Core Bus Corridor 3: Ballymun - Preliminary Submission

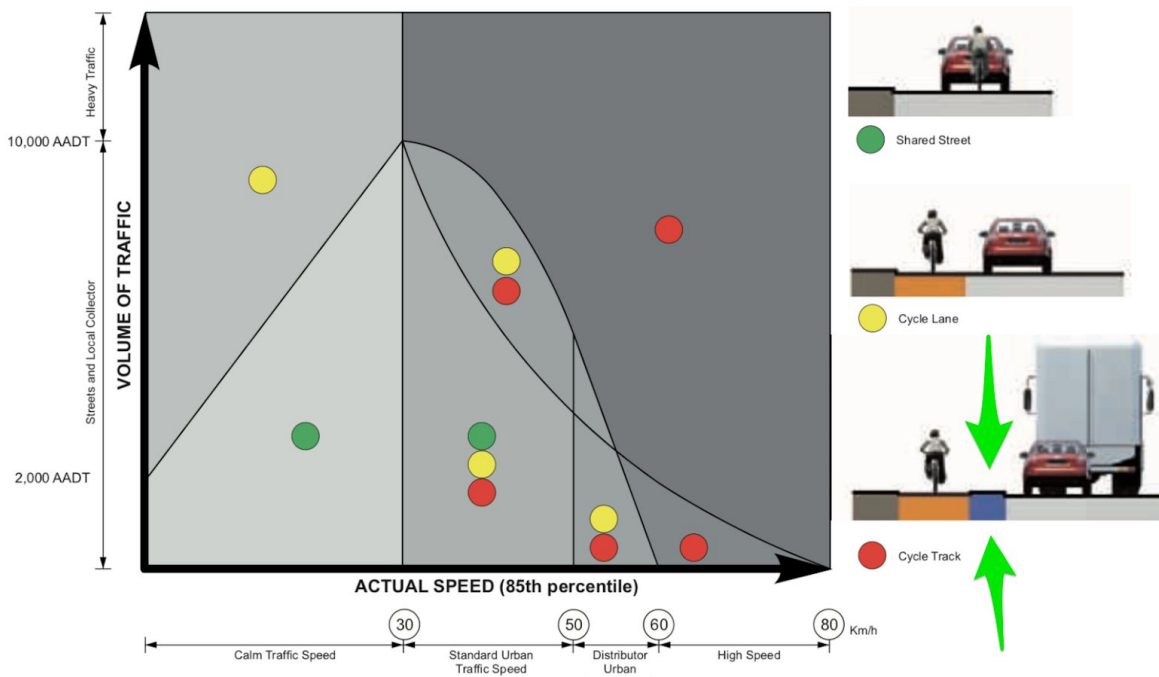
We recognise that achieving a 2.5m wide cycle track on all portions of this route may be challenging, however it is possible to achieve this width along large segments of the route by widening into the median or using grass verges beside the proposed cycle track. In constrained areas a cycle track width of 2m is acceptable, but should be implemented with caution.

5 Lamps Junction along North Strand - Junction Design Template

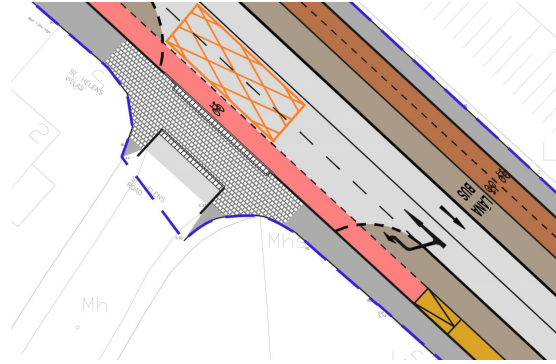
This form of junction design has been achieved along the soon to be constructed North Strand/Fairview cycle route project from Dublin City Council and the NTA. It uses a modified version of the protected junction design. The protected junction design also allows for right hand turns for cyclists.

The junction design also segregates pedestrians and cyclists by providing parallel crossings and designated spaces. This would eliminate shared spaces for pedestrians and cyclists. Shared spaces are disliked by pedestrians, cyclists and by people with disabilities. Parallel crossings also mean that cyclists don't have to use islands in the middle of the road that frequently are too small for bikes to easily manoeuvre around.

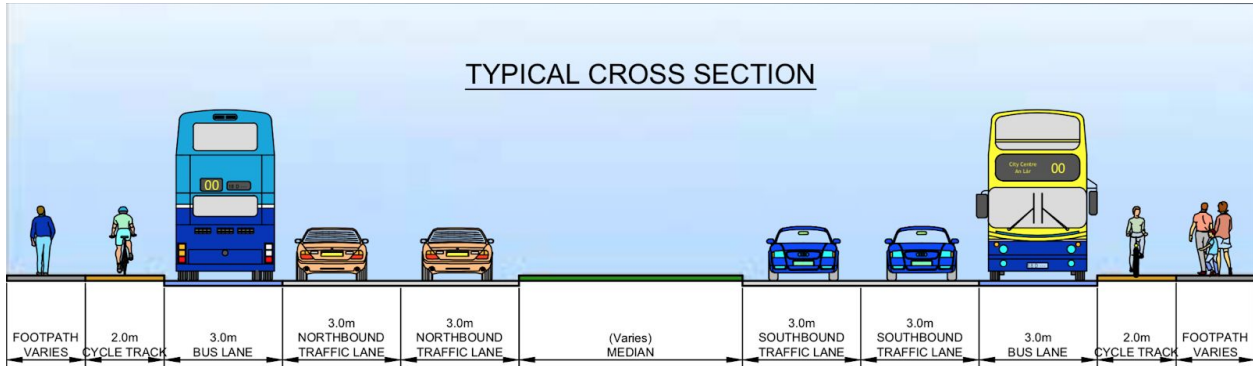
Bus stop bypasses for cyclists should be the norm, as part of these designs. There are many reasons we'd encourage the design team to include bus stop bypasses at all bus stop locations:

There is a strong case to be made for the rationalisation of bus stop locations. We strongly urge the review of bus stop locations and frequency. This will ensure greater efficiency of the bus service but also allow for greater consideration of the preferred bus stop bypass design for safety of all commuters.
